UNITED STATES PATENT AND TRADEMARK OFFICE

Office Action Summary

10/056,237

WISNIEWSKI ET AL.

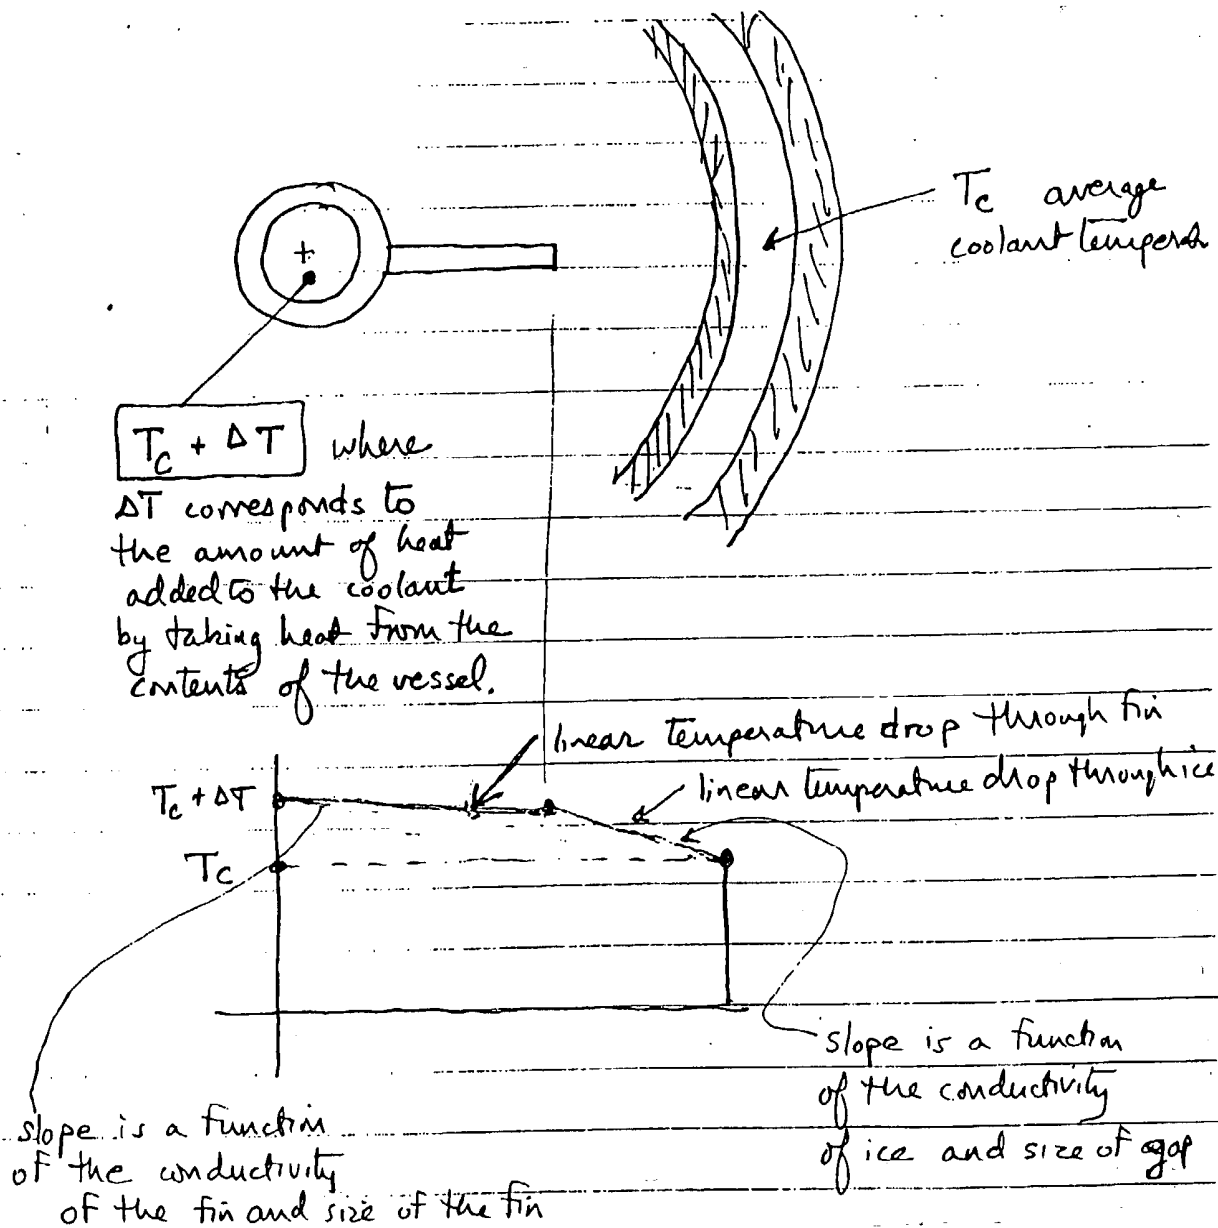
Moreover, Exhibit B incorrectly assumes the temperature in the pipe is the same as the temperature in the jacket. This is an incorrect assumption and will necessarily lead to inaccurate conclusions. The temperature in the pipe is a complex function of the initial temperature of the coolant before it passes through the jacket, the temperature of the liquid in the container and the flow rate of the coolant among other variables. As explained above, and as shown in Figure 1 (page 134) of the 1992 article, the coolant goes from the refrigeration system to the jacket and only after exchanging heat with the contents of the vessel (and thereby acquiring some higher temperature) does it pass into the central structure where it necessarily must have a higher temperature than the coolant in the jacket. Thus, Mr. Wisniewski's thought experiments are flawed because they are based on incorrect boundary conditions.

Paragraph 8, Exhibit C, like Exhibit B is simply a guess at what the temperature distribution actually is. As stated with respect to Exhibit B, the temperature distribution must either be measured or generated by very sophisticated computer programs, which have had their validity checked against measured data. Mr. Wisniewski has not done this. The results are not credible, for this reason.

Paragraph 9, Exhibit D is clearly erroneous, beyond the reasons stated above. Once the ice bridges the entire gap to a significant extent, the temperature distribution through a solid ice (non-moving interface) is relatively easy to predict analytically and
